INSTRUCTIONS FOR UPDATING YOUR ER

To update your copy of the Clinton Power Station - Units 1 and 2 Environmental Report - Operating License Stage, please remove and destroy the following pages and figures and insert the Supplement 1 pages and figures as indicated.

**CLINTON POWER STATION
UNITS 1 AND 2**
ENVIRONMENTAL REPORT-OPERATING LICENSE STAGE

S.1-23 **POOR ORIGINAL!**

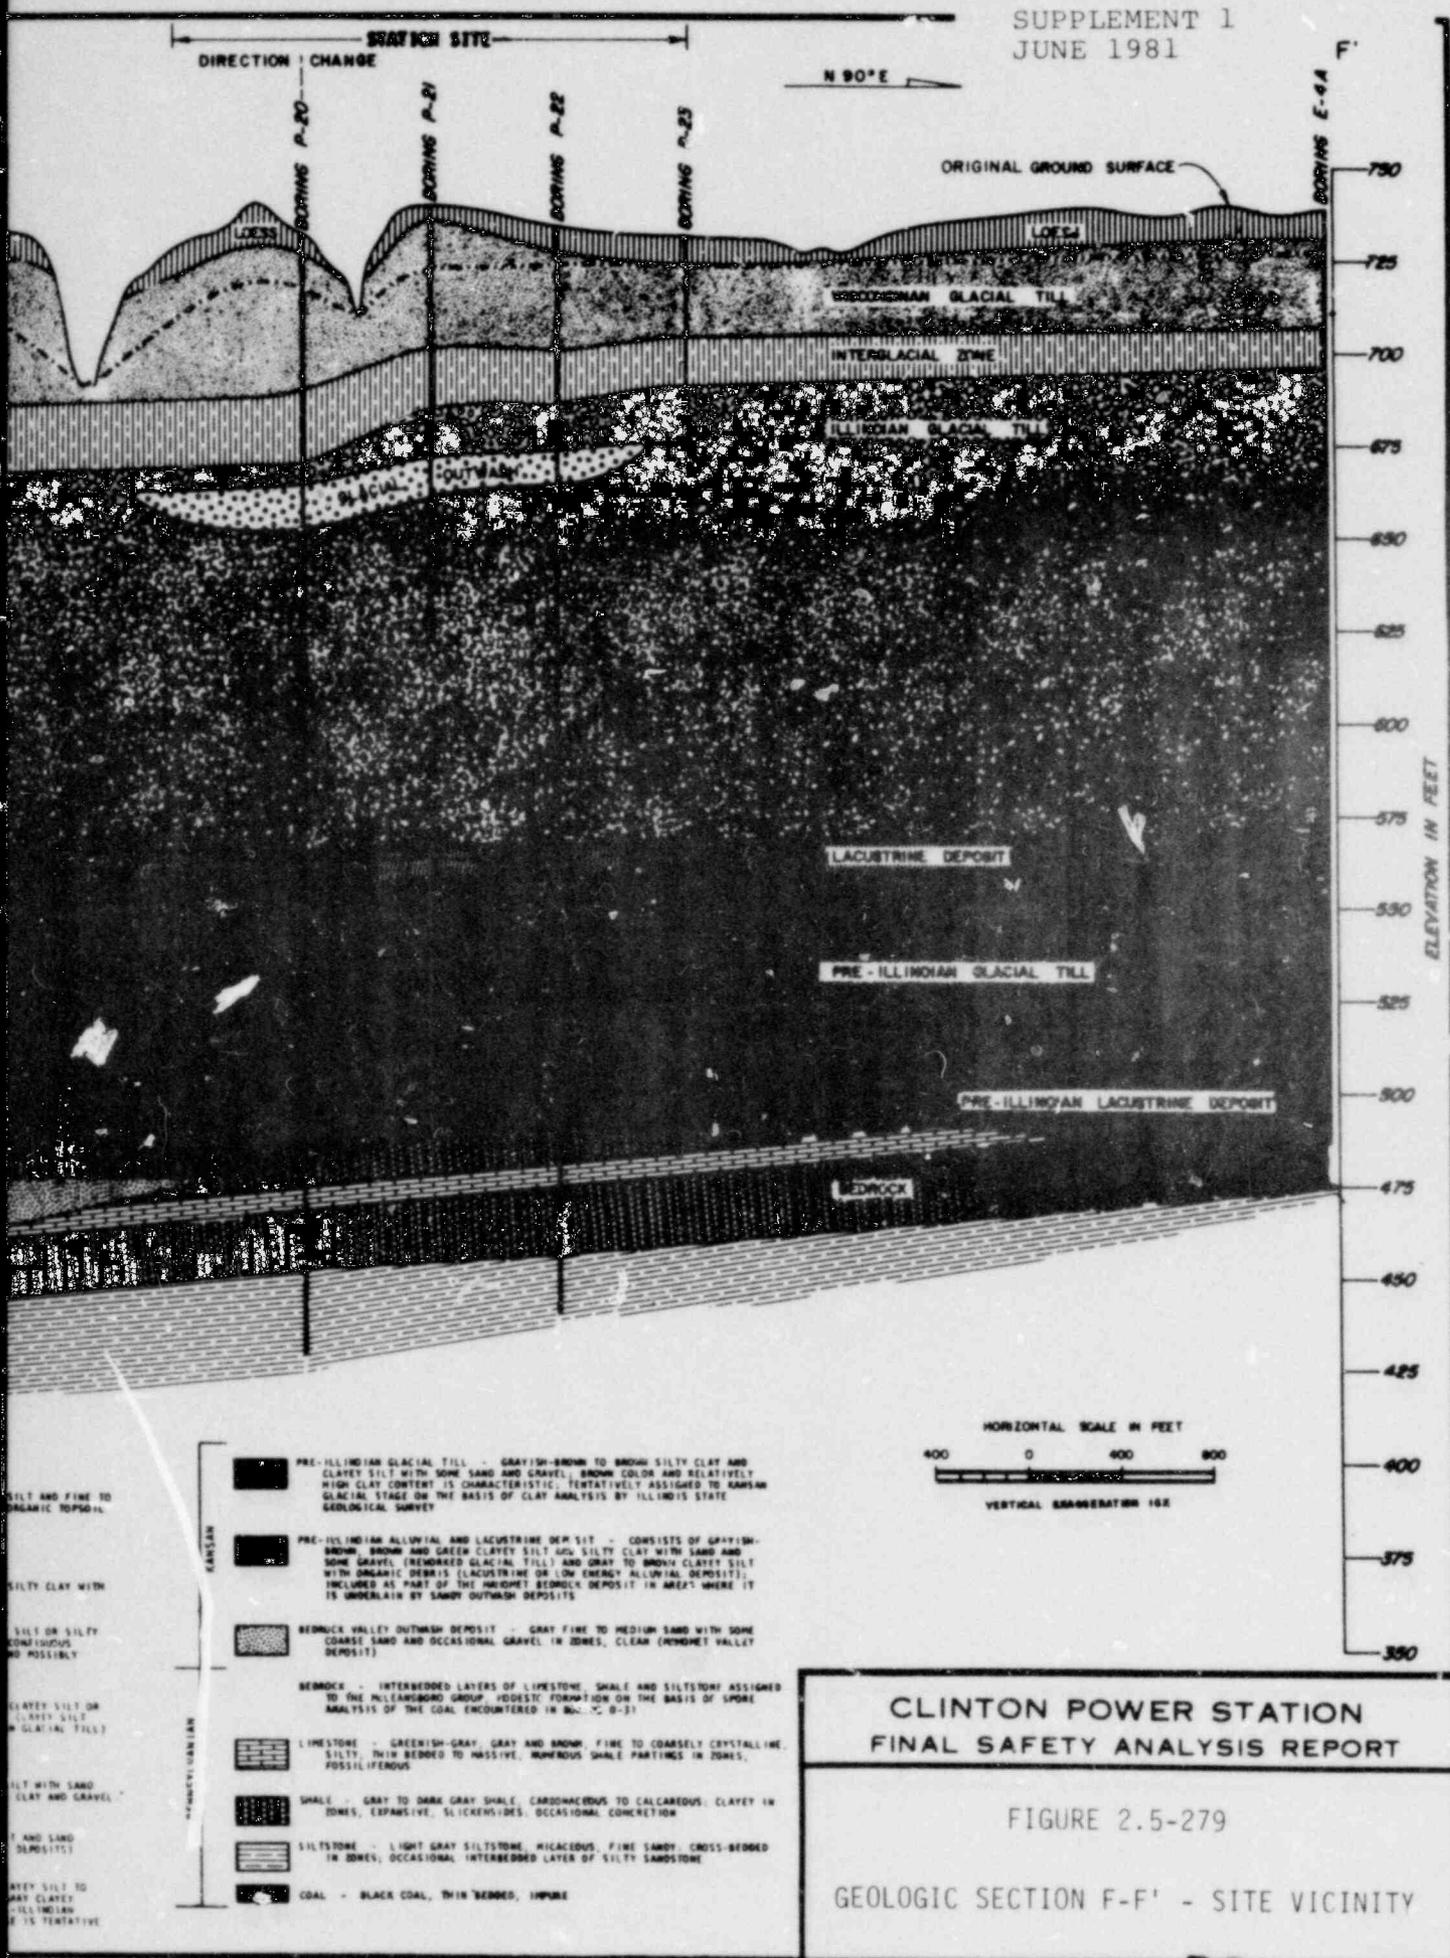
The topography or shape of the lake bottom is shown on Figure 2.4-5 of the CPS Environmental Report-Operating License Stage [CPS-ER(OLS)]. The contours shown on this figure indicate that the landform of the lake bottom is primarily a floodplain of Salt Creek. This landform is a recent modification of Quaternary landforms due to flooding.

A discussion of the agricultural soil associations is presented in Subsection 2.5.3.1.1 of the CPS-ER(OLS). The locations of the agricultural soil associations are shown on Figure 2.5-3. The soil associations of the lake bottom are the Huntsville-Sawmill Association, the Alexis-Littleton-Camden Association, and the Strawn-Hennepin Association. Subsection 2.5.3.1.1 discusses the geologic units from which the soils developed. The agricultural soils are generally developed in the upper 5 feet of the Quaternary deposits (Smith and Smith 1940).

The Huntsville-Strawn Association shows little or no profile development and varies in character according to the recent sediments of which it is composed. The Alexis-Littleton-Camden Association has an upper layer 3 to 8 inches thick composed of silt loam. The subsoil begins at 10 to 15 inches and is composed of yellowish-brown clay loam. Below 40 to 60 inches, stratified sands and gravels are found. The Strawn-Hennepin Association has an upper soil layer of silt loam. The subsurface is a grayish-yellow silt loam, and the subsoil, which begins at a depth of about 10 to 12 inches, is a yellow silty clay loam that often contains considerable gravel. Below 20 to 40 inches, friable calcareous till is found. The Strawn-Hennepin Association makes up less than 400 acres of the entire lake bottom.

Below the agricultural soils are various Quaternary units overlying Pennsylvanian-age bedrock. Figures 2.5-278 and 2.5-279 from the CPS Final Safety Analysis Report (FSAR) have been included in this response to show the typical relationship of the Quaternary units. A complete discussion of site stratigraphy is presented in FSAR Subsection 2.5.1.2.2.
